**Statement of Response to An Bord Pleanála's Opinion  
in relation to Reg. Ref.: ABP- 308478 -20**

**A Proposed Strategic Housing Development**

**Hacketstown, in the Townland of Milverton and  
Hacketstown, Skerries, Co. Dublin.**

**Land Development Agency**

**Figure 2.1: diagram of public open space, communal space and other areas. (Source: BSLA, 2022).**

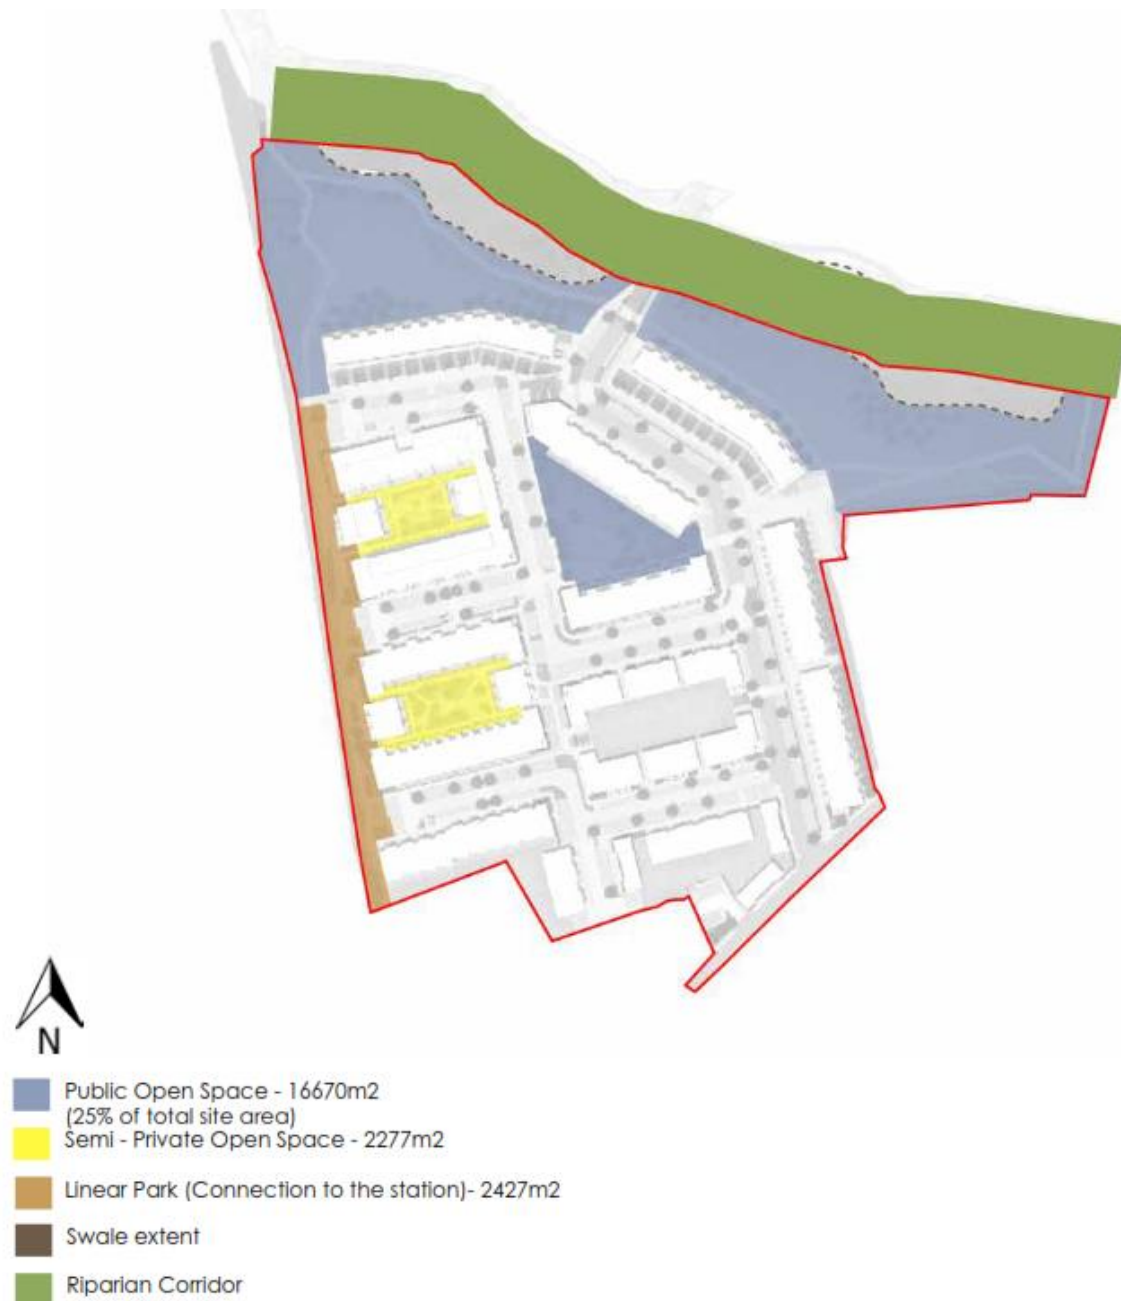
*A plan of landscape proposals clearly delineating public, communal and private spaces to be provided, as well as a detailed breakdown of the total area of same. Consideration of how the design of the landscape and provision of furniture/equipment will facilitate use of these spaces for both adults and children should be provided.*

*Details of how the edge of the parkland area will be treated where it meets streets should be provided. The design treatment and enclosure of communal residential gardens should also be explained. A response to the comments from the Planning Authority in relation to the landscape proposals is required.*

- 2.16. The landscape design rationale has been set out in BSLA Landscape Design Statement and associated drawings. A clear delineation between public, communal and private spaces are set out in DWG No. DN1906\_BSLA\_LDA\_SHD\_Landscape Detail - Open Space. Figure 2.1 below illustrates this.

- 2.17. The proposed Public Open Space which is 16,670 sqm in size, the proposed communal open space is 2,272. The landscape design aims to utilise the existing contours in order to cater for a natural water run-off that supply the main water attenuation areas and enhance the vibe of the landscape by their presence. These areas will be planted and presented as areas that will attract insects. Gradual and attractive slopes designed to provide a useable space can be used for both habitats and as informal amenity. The approach has been coordinated with the adjacent Noonan Construction site which encourages clear landscape connections and mutual visual links as it ensures that a functioning and offering rich in amenity can be maximised to benefit both sides.

**Figure 2.2: diagram of site constraints. (Source: OMP, 2022).**

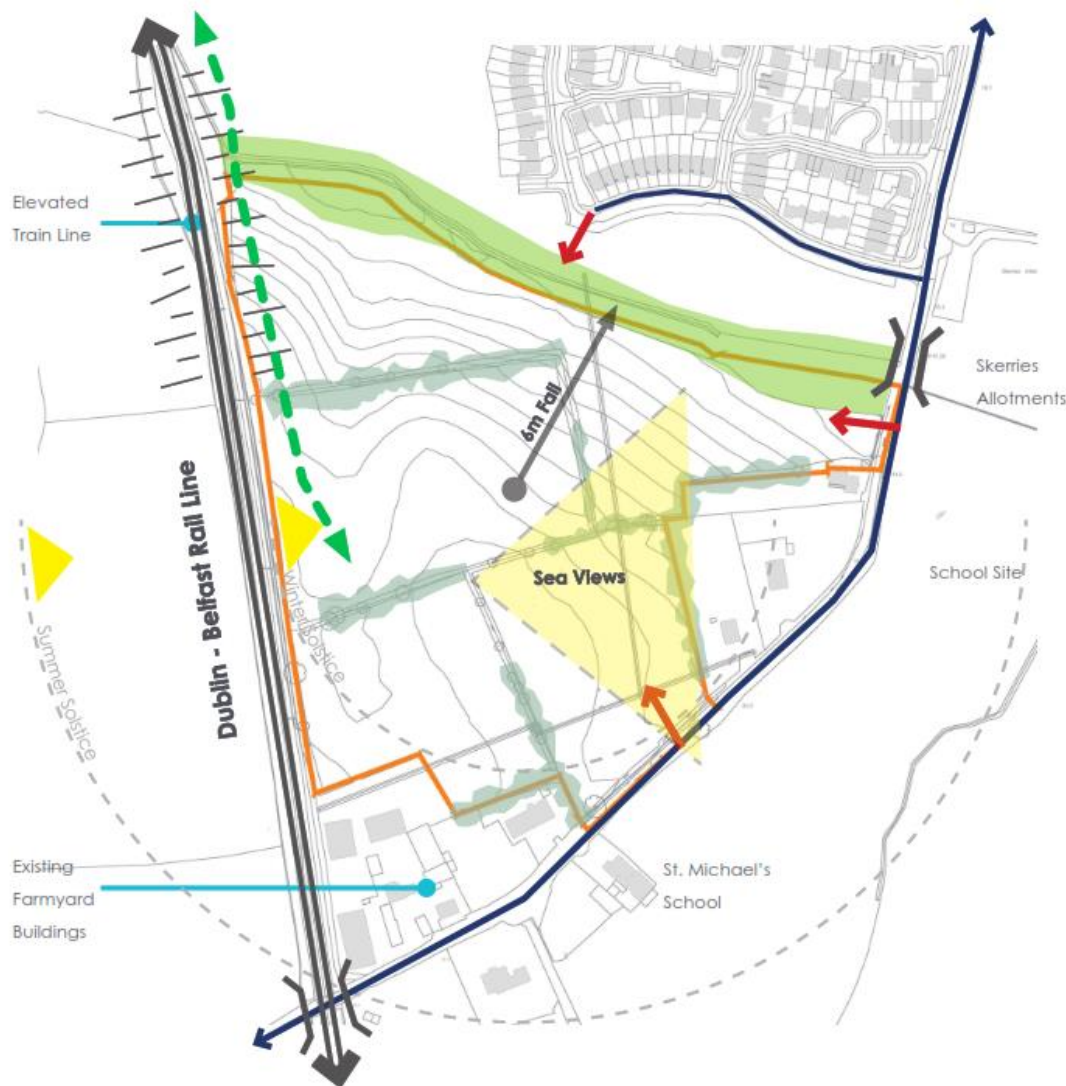
*Topographical survey of the site and associated commentary on how this has impacted the design of the proposed development and arrangement of open space.*

- 2.29. A topographical survey has been carried out has informed the overall design and layout of the proposed development. OMP's Design Statement sets out the site context and response to the site which states:

*"A further constraint is the topography of the lands which fall circa 16m from the southern entrance off the Golf links Road towards the north and the stream. Additionally, the final third of the site sharply falls circa 6m with a 1:4 fall, creating a dividing 'ridge' between the plateau to the south and the basin to the north.*

*The character of the lands has a significant impact on our response to the site layout solution for the lands. The considerable fall impacts the location and access of dwellings, the typology and buildability of forms and at the same time, will provide a unique setting for a focused public realm."*

**Figure 2.6: example of long stay bicycling parking solutions proposed (Source: BSLA, 2022).**

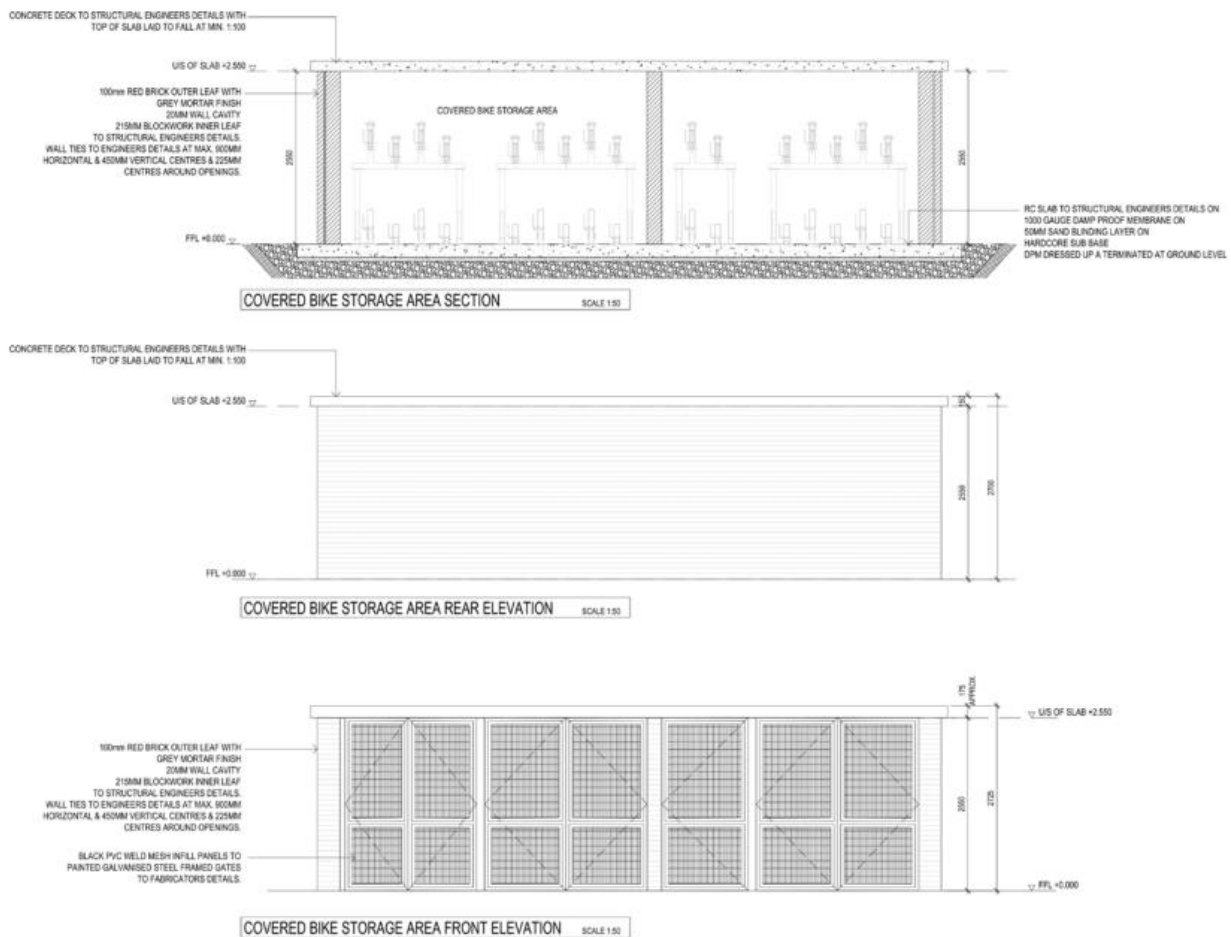
*Identify the location of cycle storage, its allocation to units and how appropriate security is achieved.*

- 2.39. The location of cycle storage, allocation to units and details of security measures have been set out in OMP's Design Statement, please see drawing number xxx for precise

details. Section 4.8 of the BSLA Design Statement also provides additional detail for the cycle parking.

- 2.40. 802 No. bicycle parking spaces comprising including 128 No. visitor spaces and 10 No. to serve the creche.
- 2.41. The location of the proposed Long Stay (Residents / Creche Staff) and Short Stay (Visitors) bicycle parking is detailed in Section 5.1 of the applications Traffic and Transport Assessment Report.
